Building 'D' Revised Final Design

May 3, 2010

DRB Comments from 4/19 Meeting

Revised Ground Floor Plan

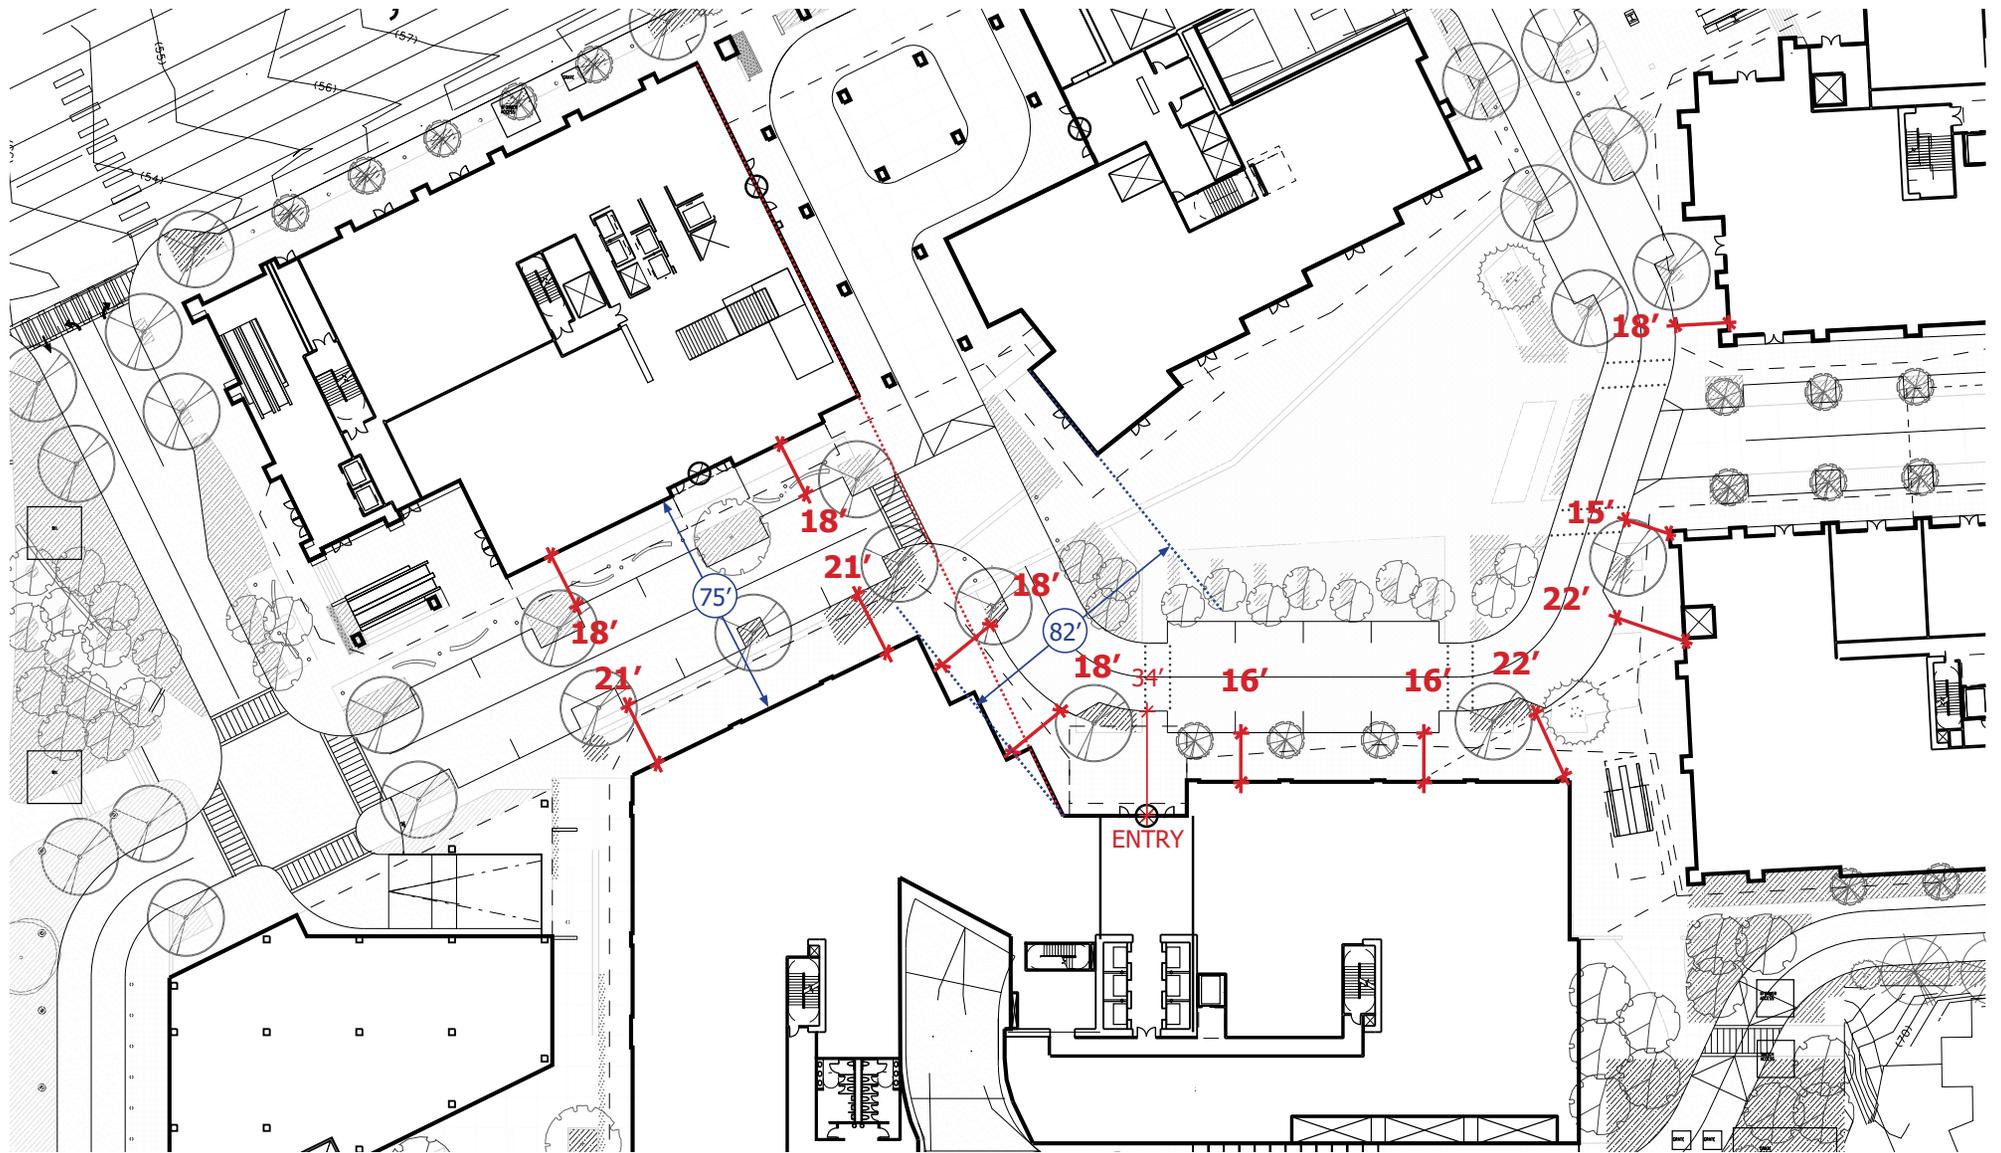
2. The DRB thought the shift of the retail out to the sidewalk was a good solution, however, the shift of the retail and gasket northward have created too much necking of the streetscape and impeded views from the park into the plaza. The design team should consider shifting these forms in a manner that improves the visual access to the plaza with methods such as chamfering the retail space at the 3rd column line.

Revised View from South

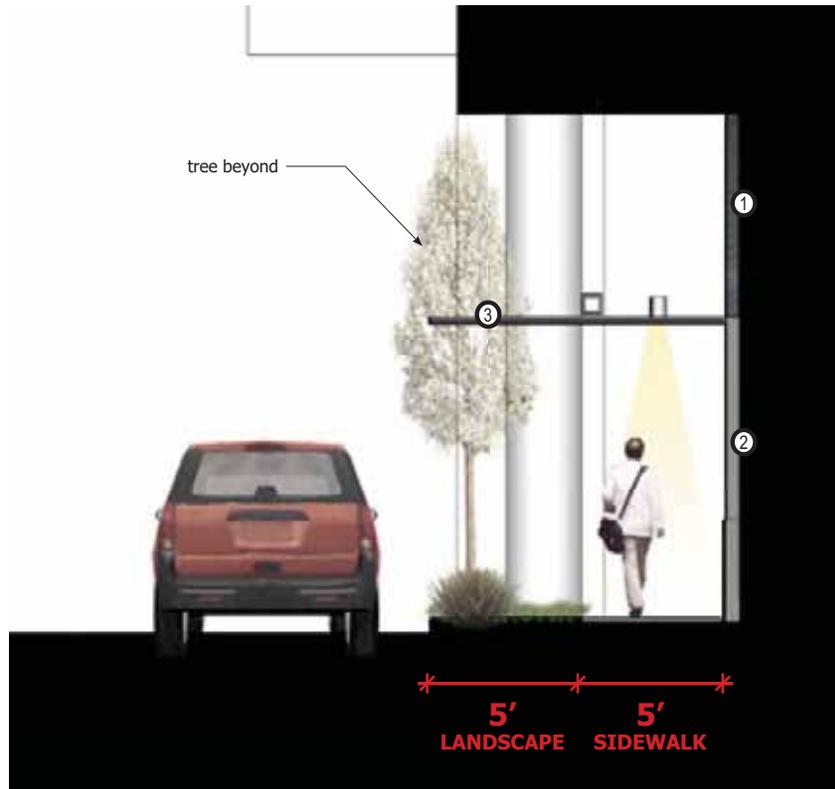
3. Since the poplars along the south side will be removed, they should be removed from all drawings.

5. The south elevation still requires additional definition and articulation in response to neighboring properties. This is not a primary façade and does not require the same response as the north façade, but does require more than has been proposed.

Alternate View from Central Plaza

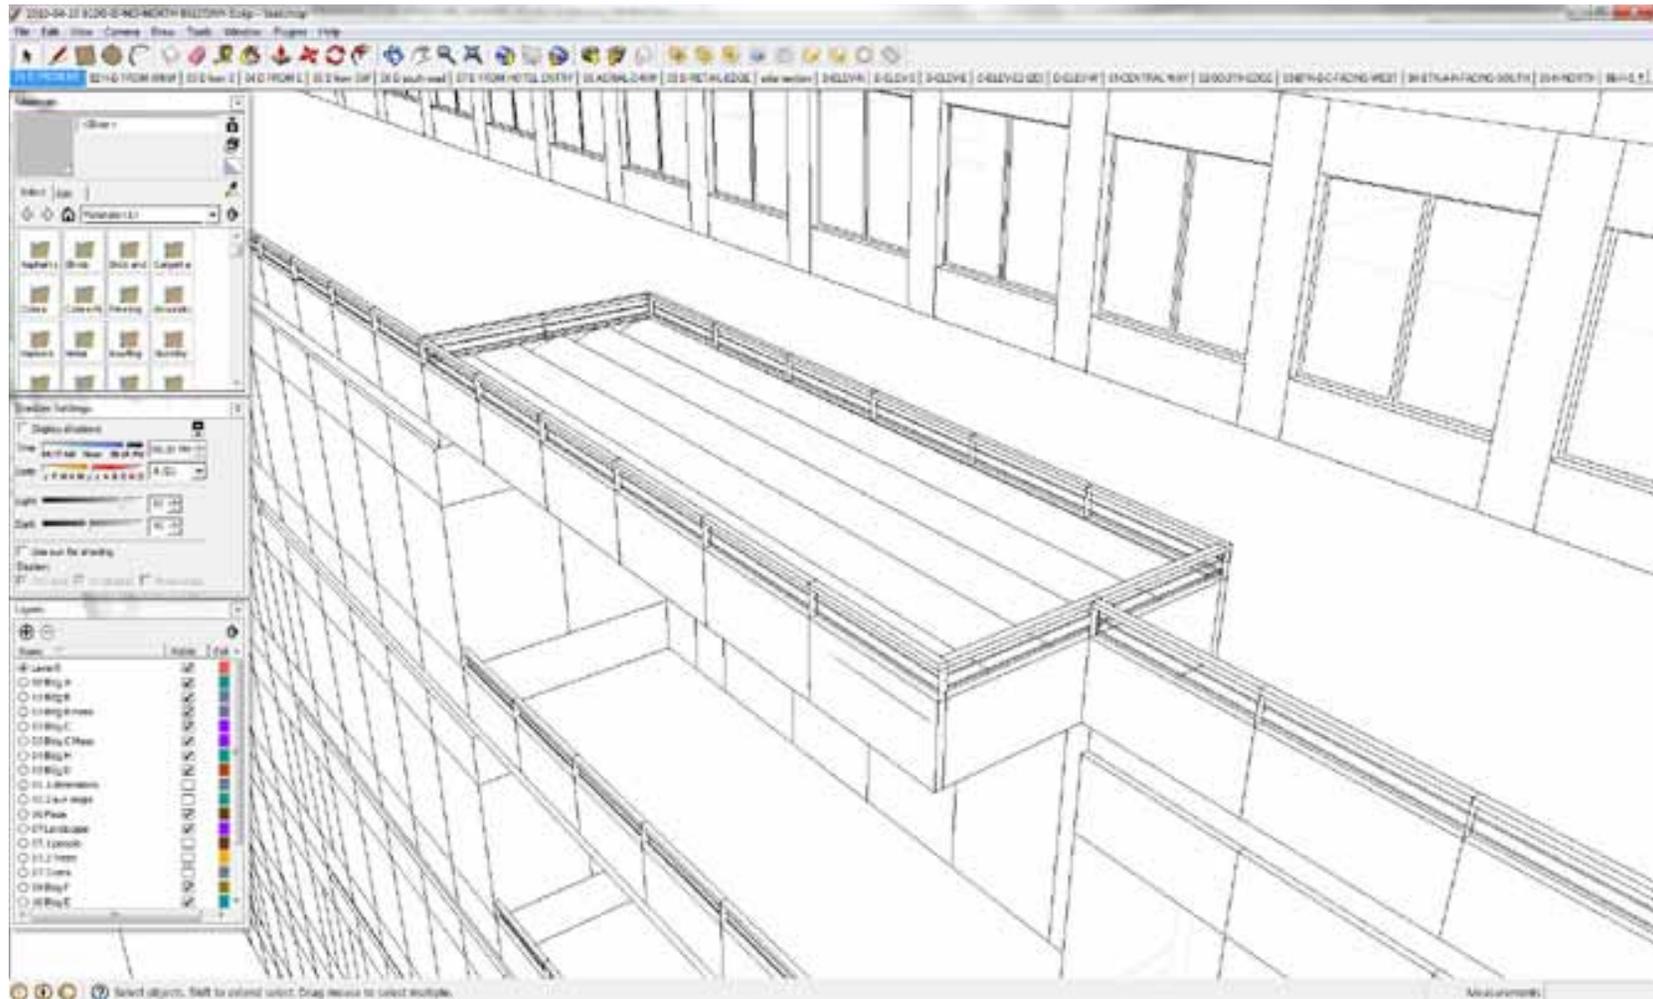
6. Study opening up the roof over the top balcony on the north façade (e.g. – opening, or skylight) to enhance the existing modulation of the buildings skyline.

Revised View from East

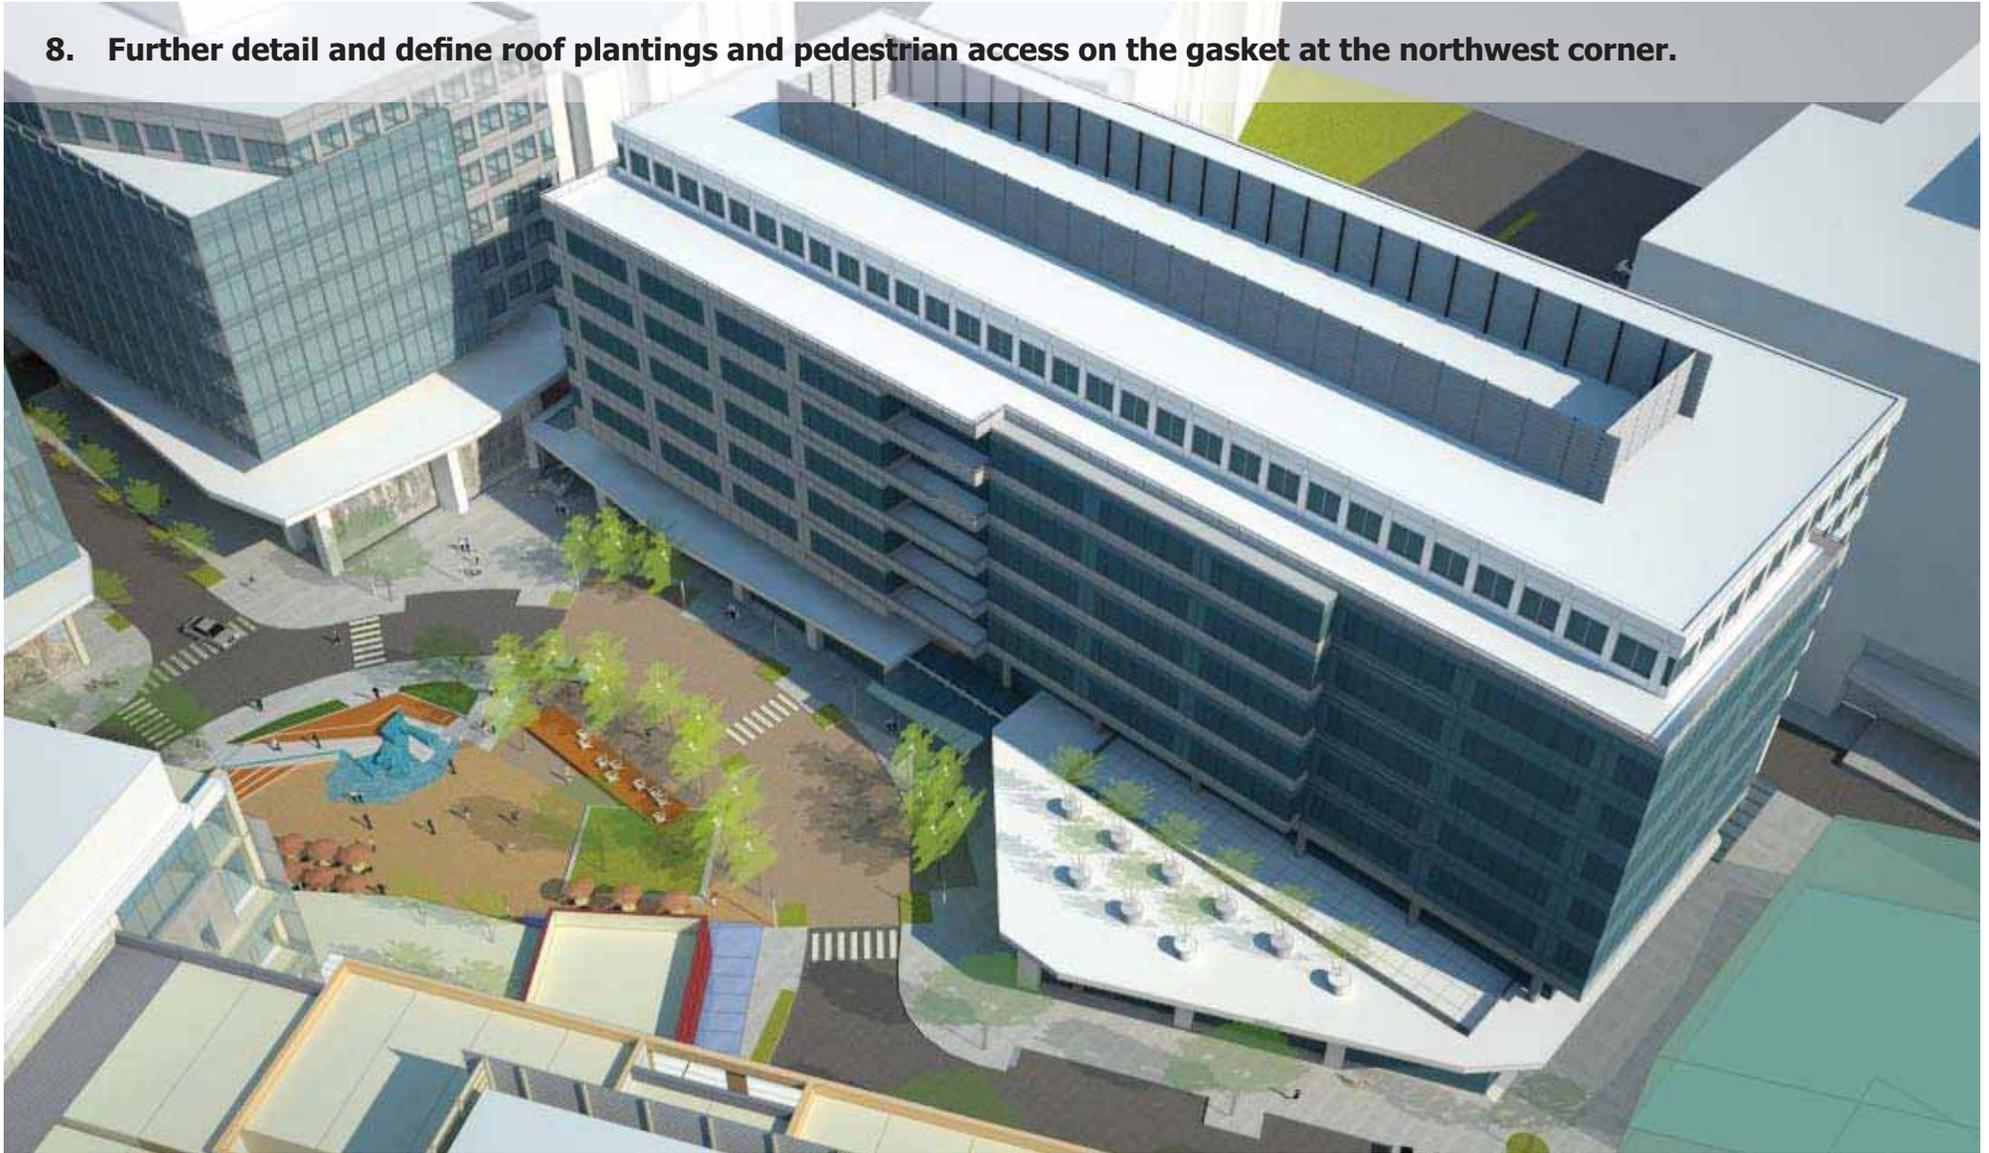
7. Review transition of the proposed green wall on the east façade as it turn the corner to the south façade.

Building D NW Illustrative Gasket Planting Plan

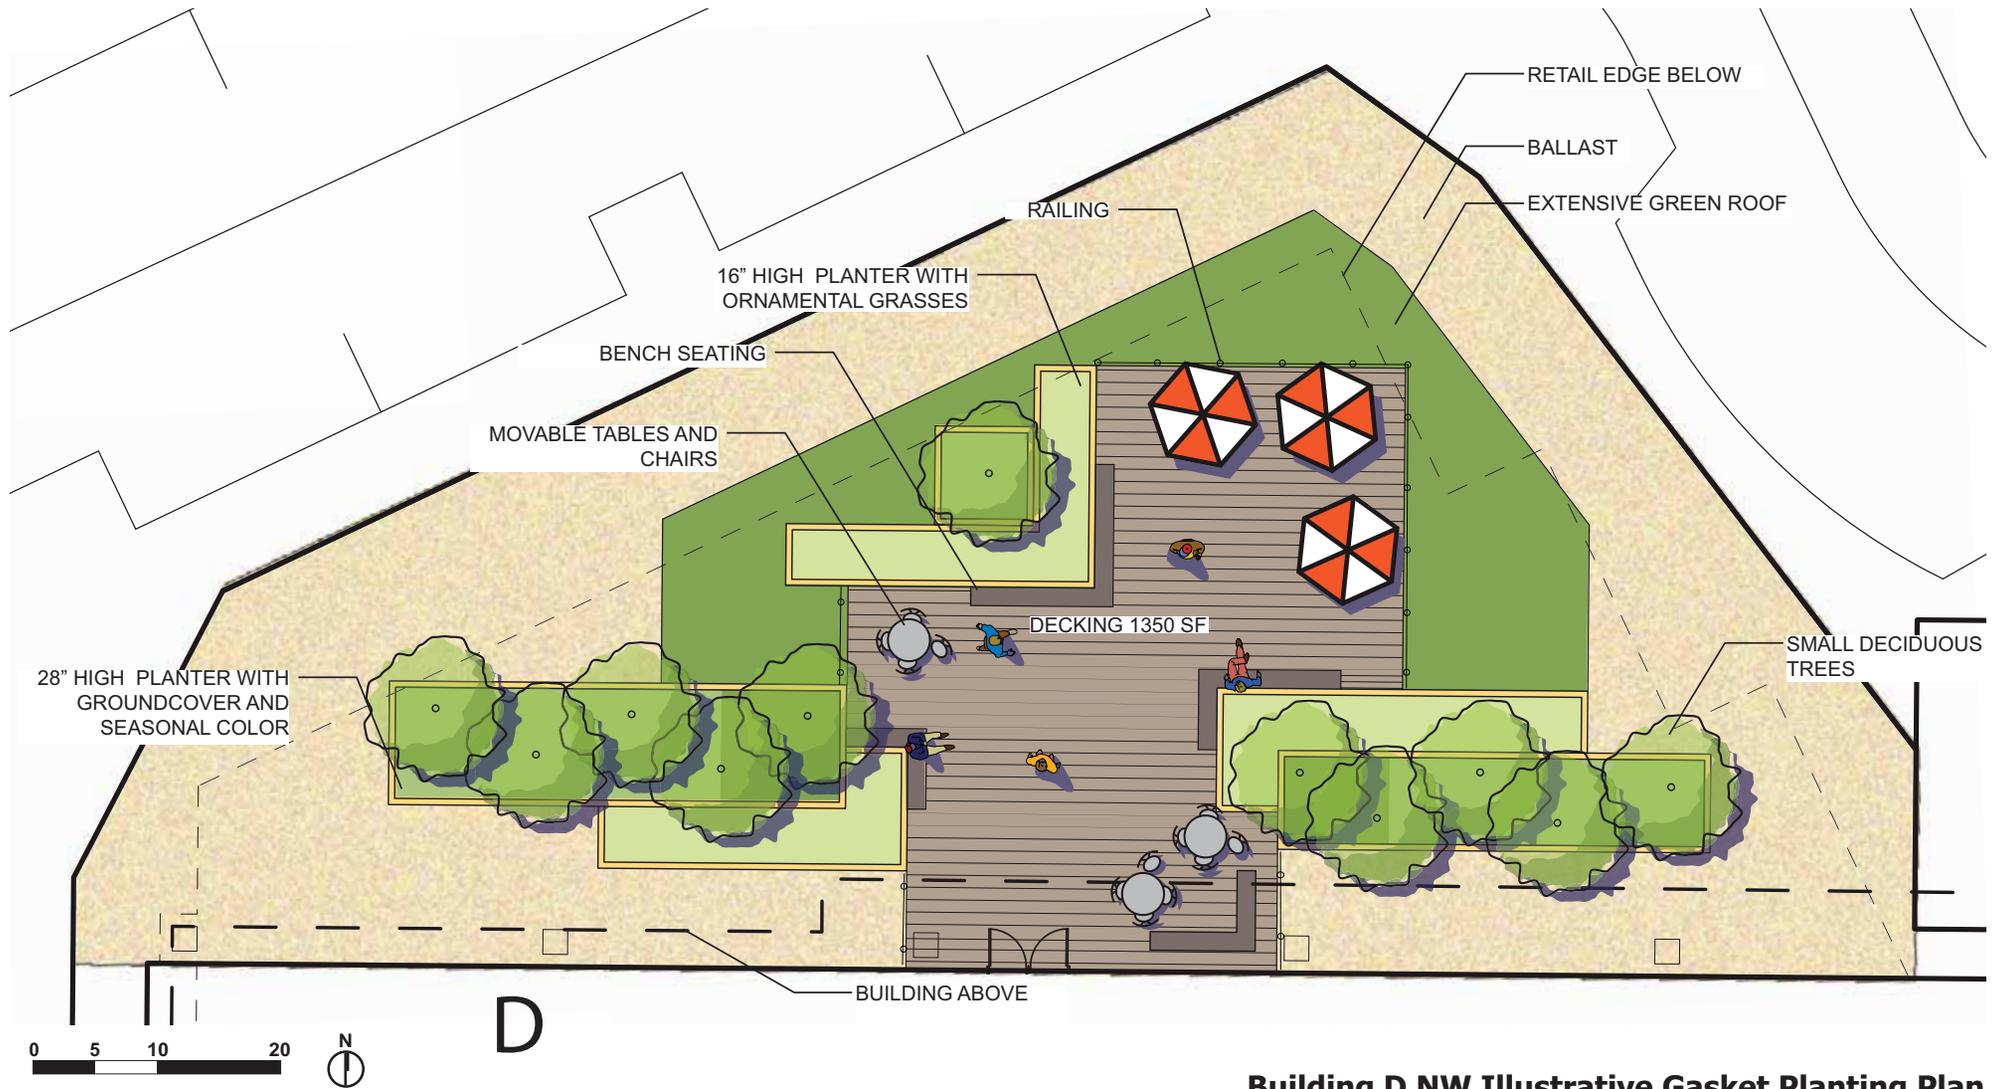
8. Further detail and define roof plantings and pedestrian access on the gasket at the northwest corner.
